Access Compliance Report

Public Rights-of-Way

(Curb Ramps)

Intersection ID: 54422	Main Street: LISMORE_LN	Cross Street: KILKENNY_DR	Location: SW
ADA ID: 5D8BE86604DE	Ramp Type: Directional1	Initial Pass/Fail: Fail	Overall Compliance: No
Codes/Mitigation Info/Possible Solution		Field Measurements/Component Compliance	
Severity Score: 1.25

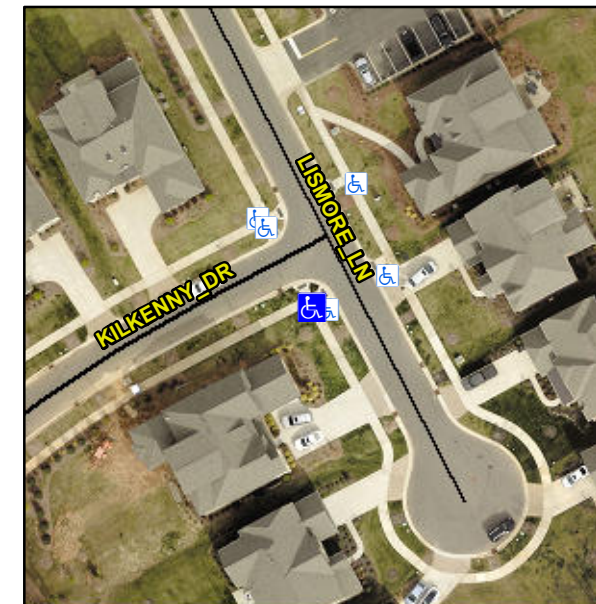
Remove & Replace Entire Ramp.

ROAD TO BE RESURFACED

R304.5.3
